Proposal for editorial corrections to ECE/TRANS/WP.29/2008/81  
(Insertion of ESC into Regulation No. 13-H)

PROPOSAL

Figure 1. Steering wheel position and yaw velocity information used to assess lateral stability.

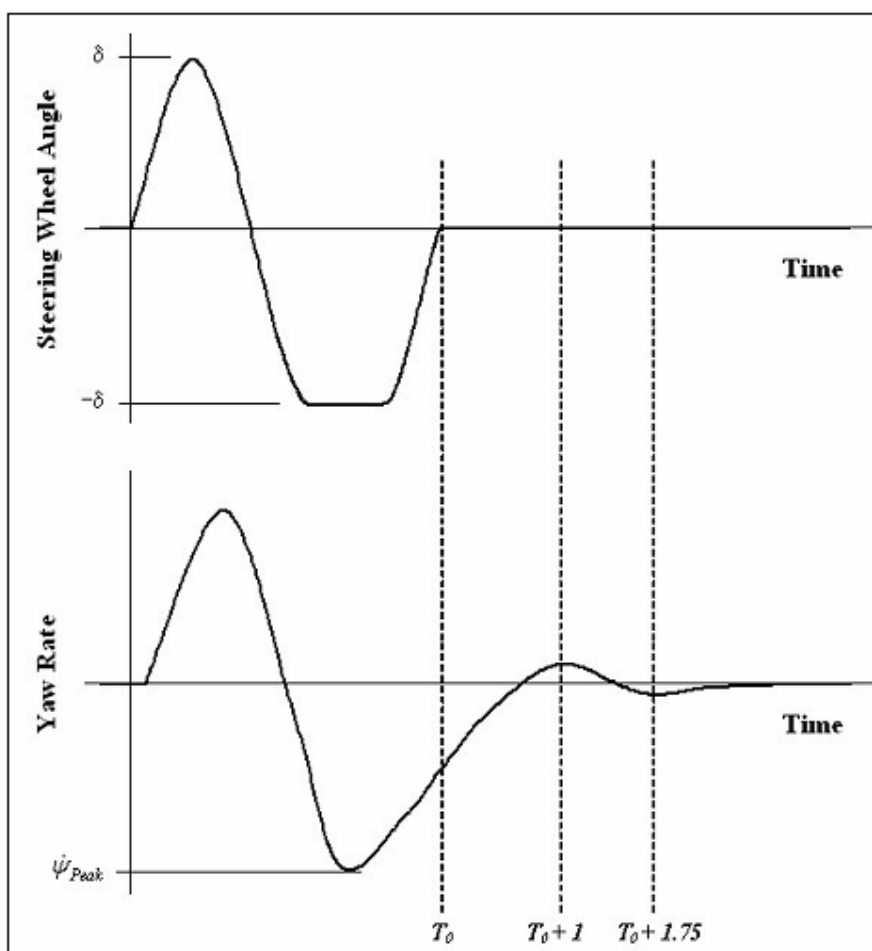
Page 6, paragraph 3.1.

Replace the existing figure by the following one
